SONI Grid Code Modification Proposal Form

Title of Modification Proposal:

SPID (SONI PROPOSAL ID) **03_2021**

The various DSU performance parameters illustrated in the diagram below, taken from CC13.1:

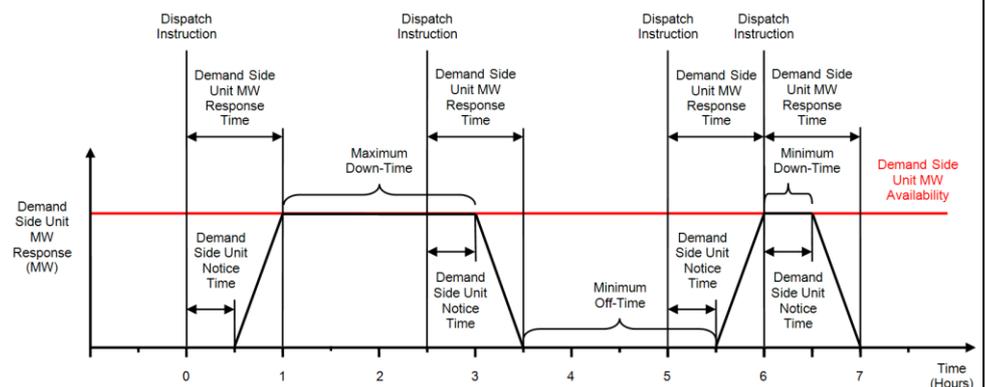
It may be worth clarifying that this diagram is only an example of a DSU where the Maximum Down Time just happens to be 2 hours, but this is not strictly necessary, as it is already possible to create DSUs with longer Maximum Down Times.

The proposed modification removes this restriction, so that DSUs can be created with any Maximum Down Time. It is only clause CC13.1(e) that imposes the restriction, and nothing else in the Grid Code or other codes seems to depend on it. The requirements on the other performance parameters in CC13.1 are left unchanged, because they are not taken into account in the Capacity Market’s de-rating factor calculations.
